Gary and Mary West Senior Wellness Center

1525 Fourth Avenue
Senior Community Center

2ND SUBMITTAL

SECOND FLOOR
SCALE: 1/8" = 1'-0"

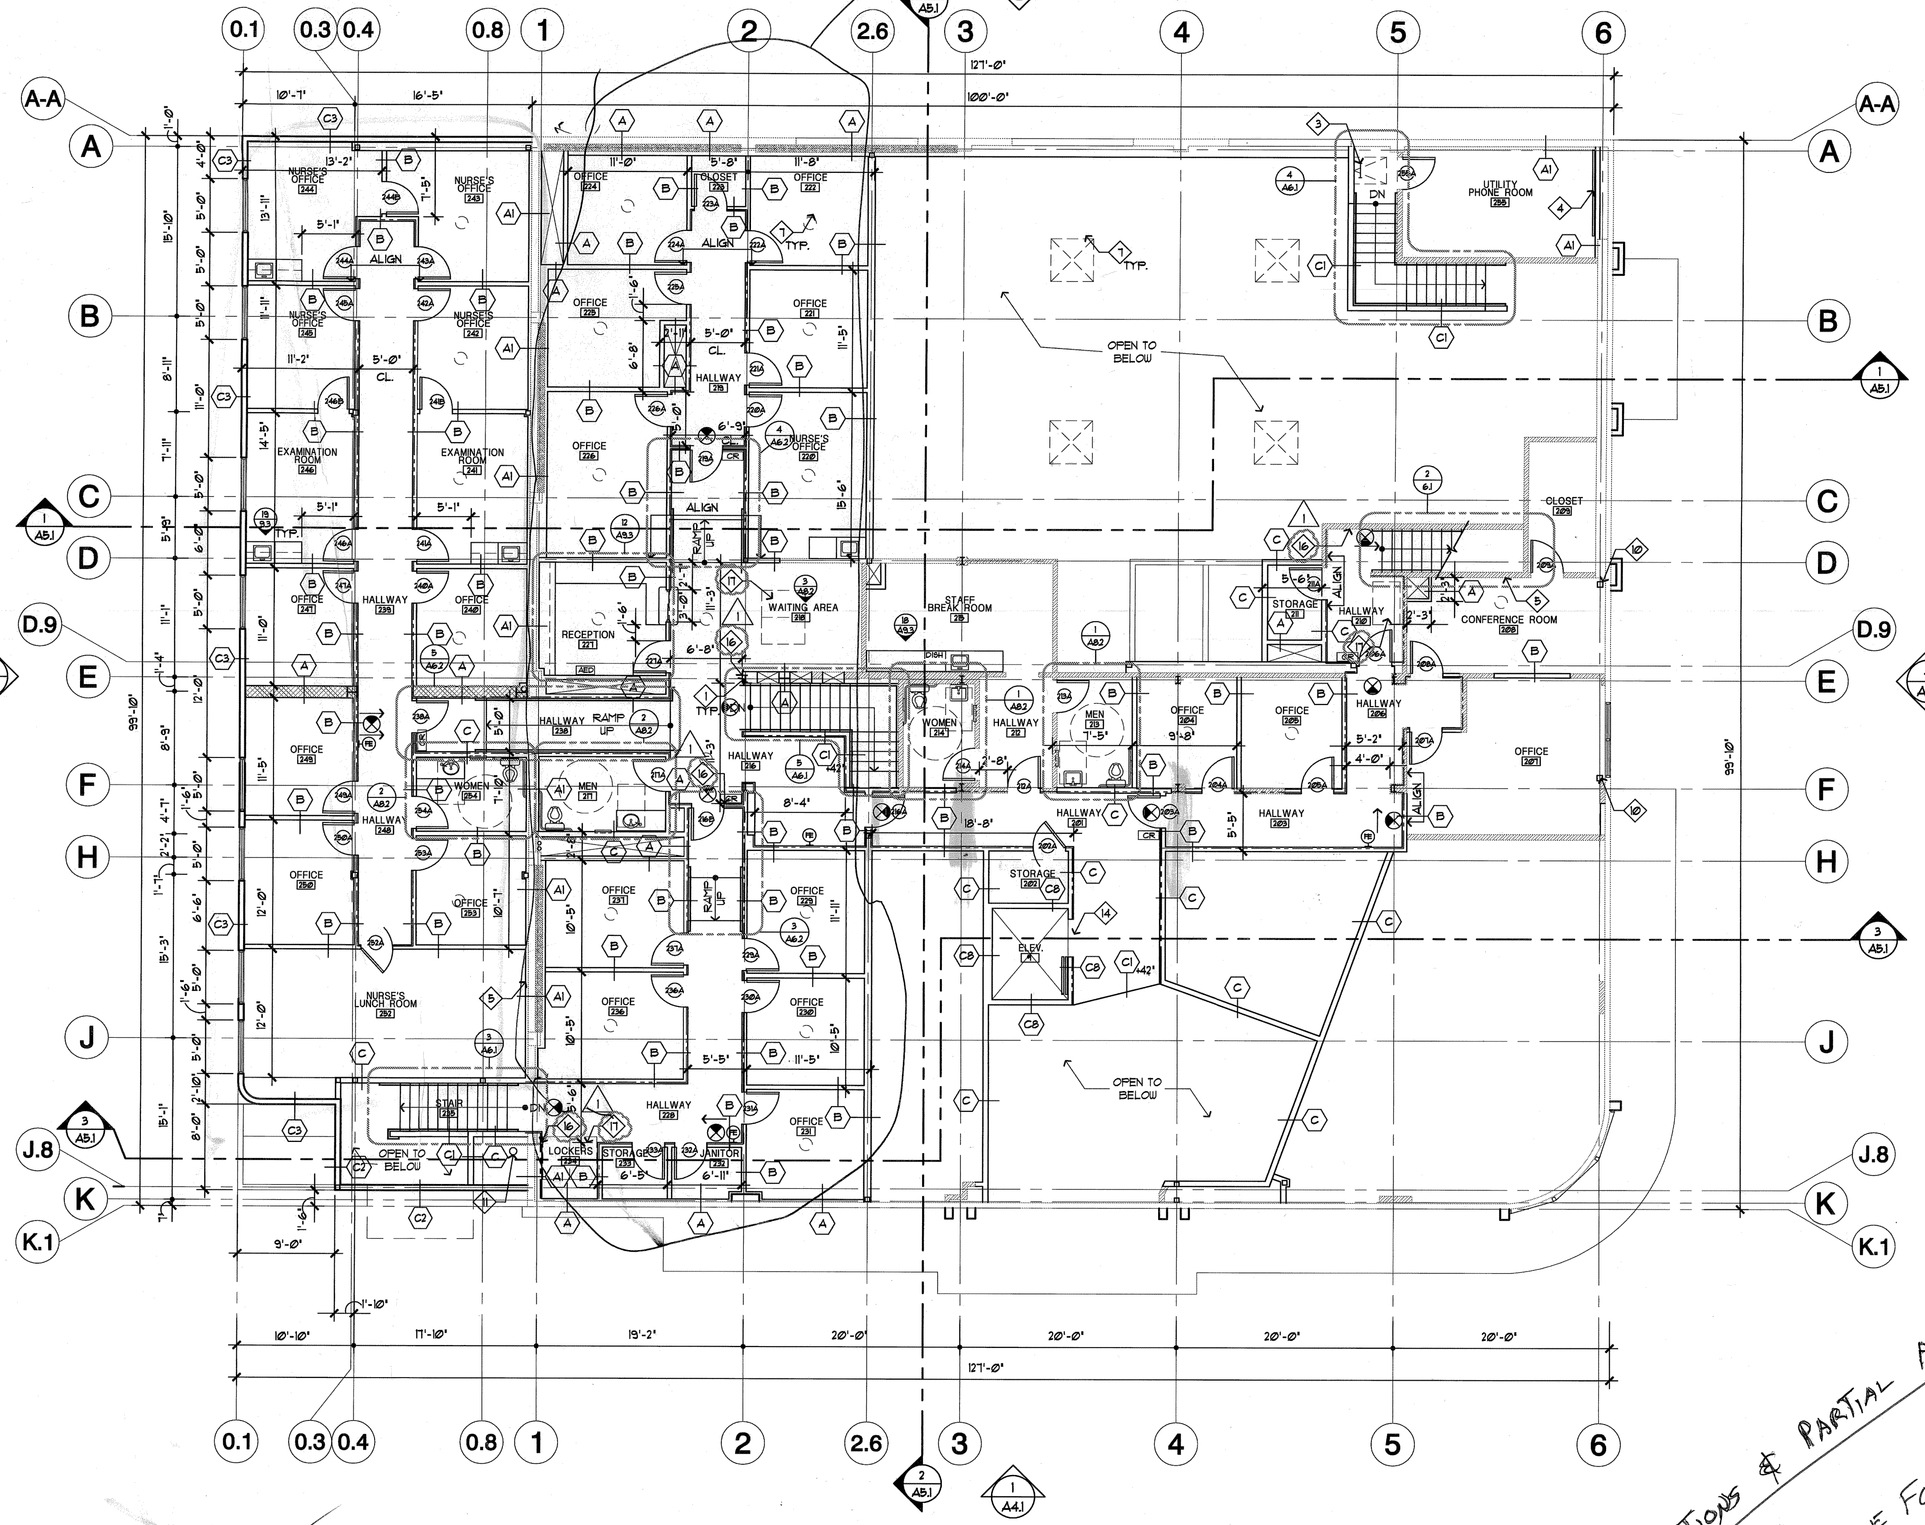
Rough Frame
INT. WALL
APPROVED PENDING
FLOOR FRAMING
CORRECTIONS
12-24-09
B. Lopez

1 CORRECTIONS & PARTIAL APPROVAL
2ND FLOOR FRAMING
IS APPROVED Except THE Following, (1) & (2)
(1) LOW STEEL BEAMS
column LINE 3 & 4 MEZZ 2ND FLR.
6'5" / MAINTAIN REQUIRED
CEILING HT. PER Bldg. CODE.
(2) 6X12 WOOD BEAMS NO HANGERS
5DS LAG BOLT 24" OC
(3) Need ALL CITY PLAN CHECK APPROVED CORRECTIONS FOR ABOVE ITEMS & Framing
12-31-09 R.Lopez
PENDING ALL TRADES
* MEZZ.
* FLOOR TRUSSES
FLOOR JOIST
FLOOR BEAMS
NOT PER PLAN
INSP. REQUIRE
WITH NEW
CORRECTIONS

MEZZANINE FLOOR FRAMING PLAN

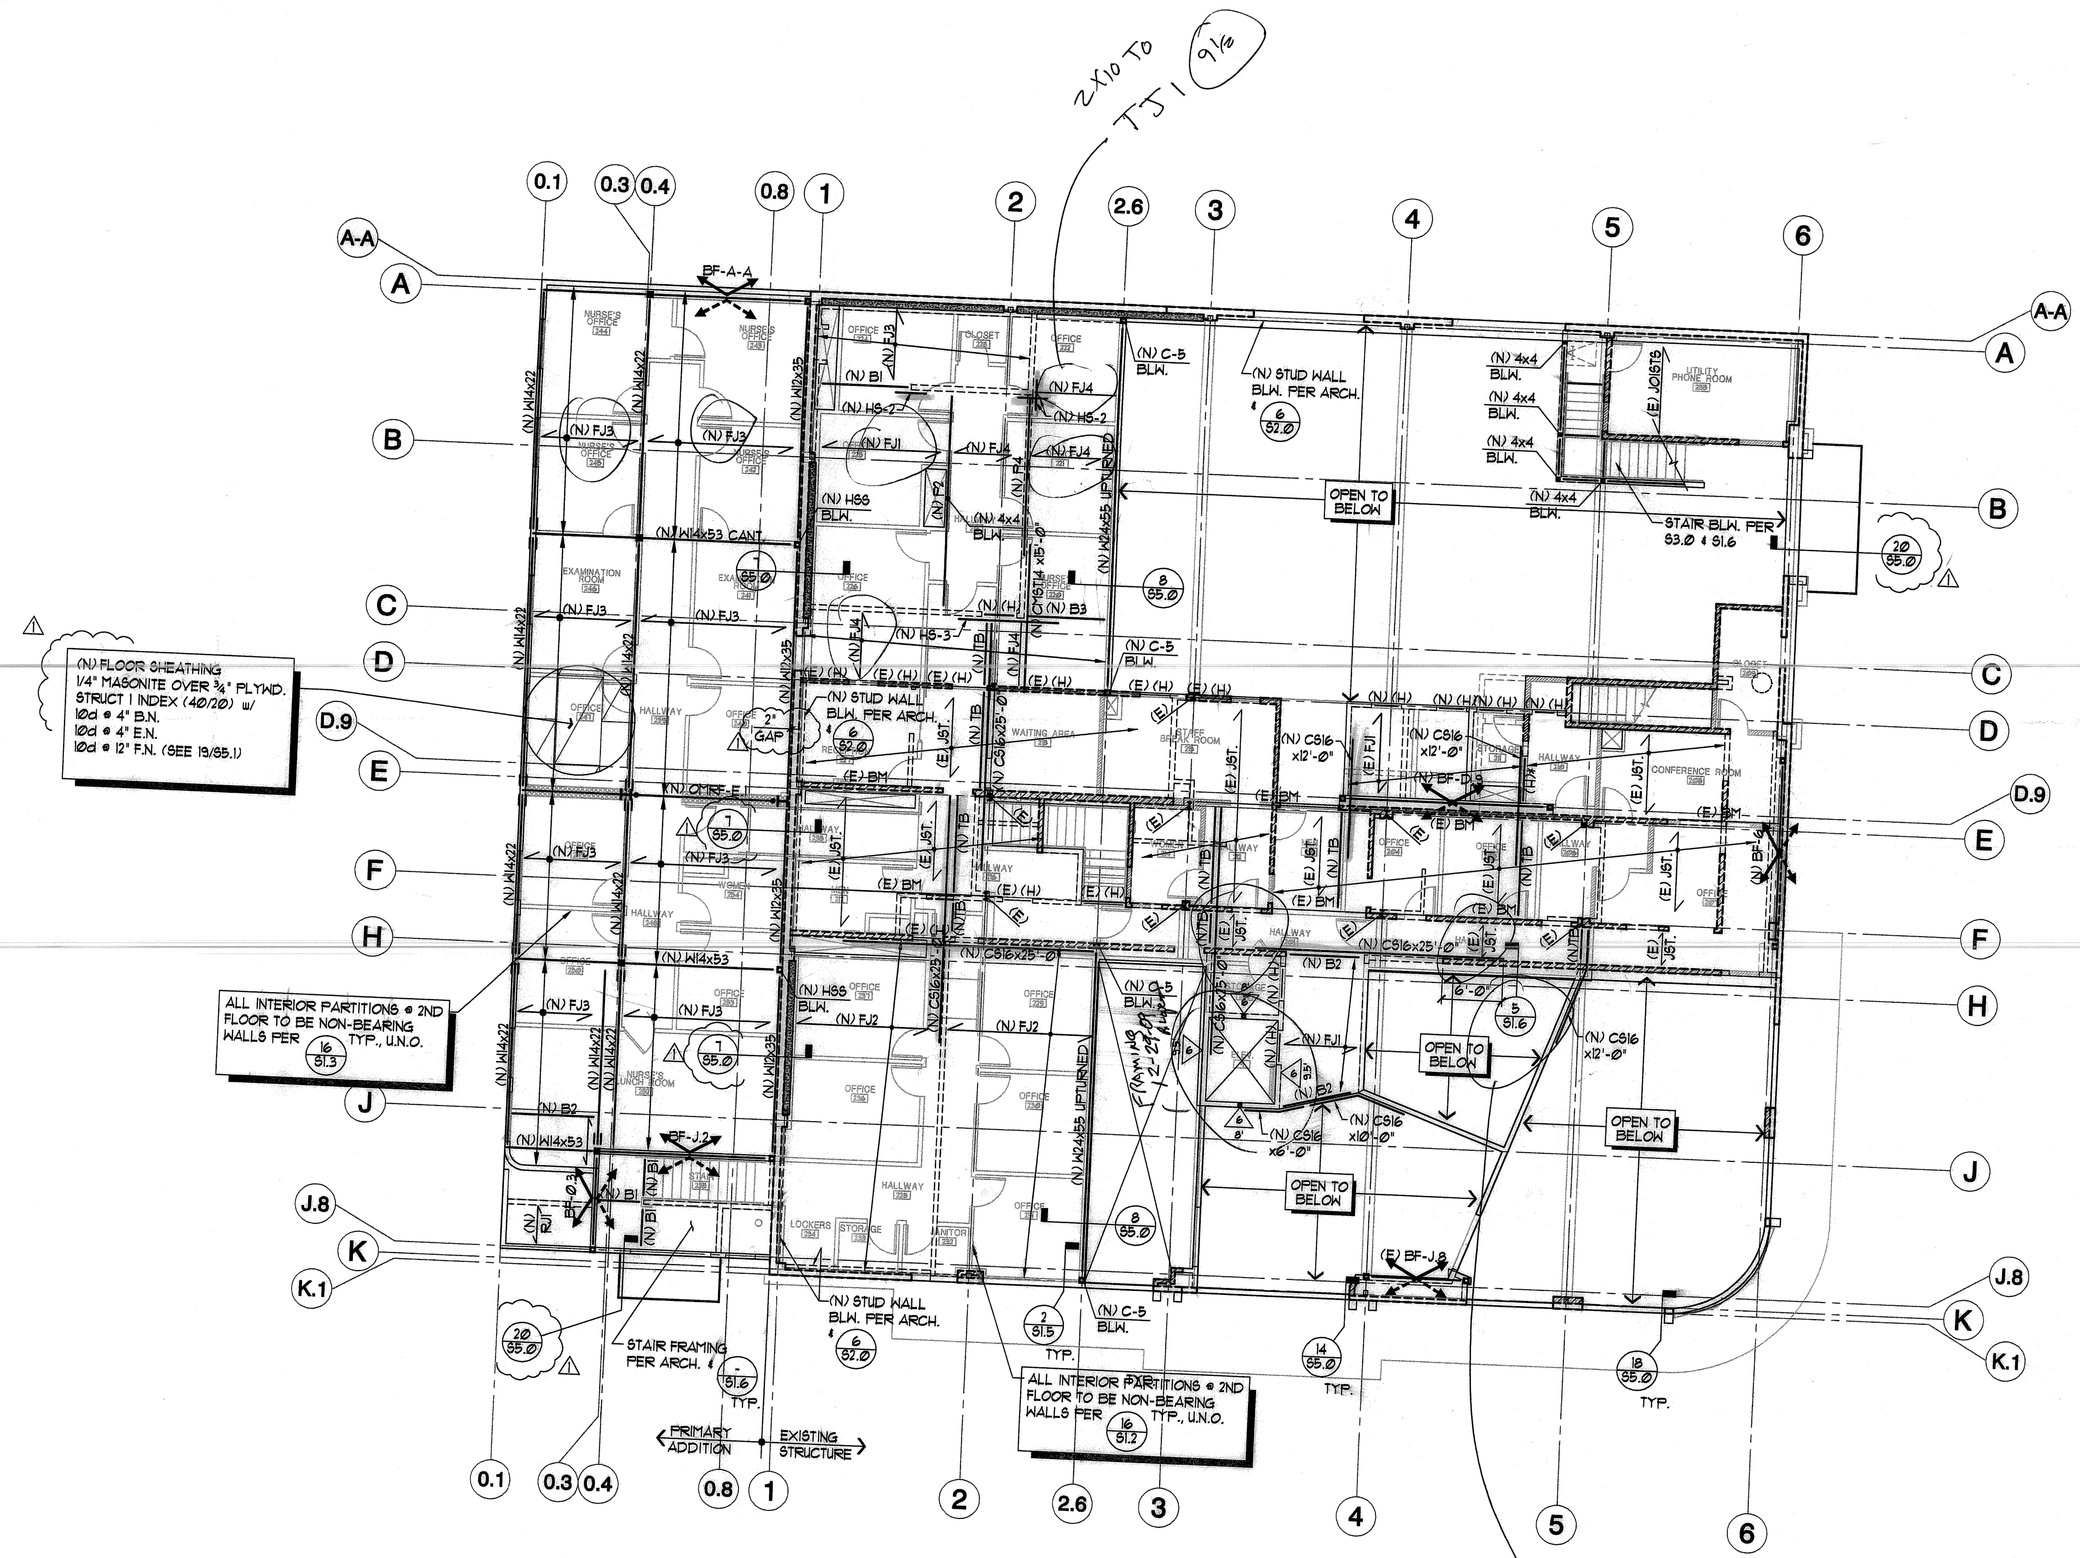
*(2) MEZZANINE 2ND FLOOR STRUCTURAL STEEL BEAMS TO LOW IN HALLWAYS. CITY STRUCTURAL PLAN CHECK APPROVED FIX REQUIRED FOR HEAD ROOM CLEARENCE, PER PREVIOUS REQUEST.
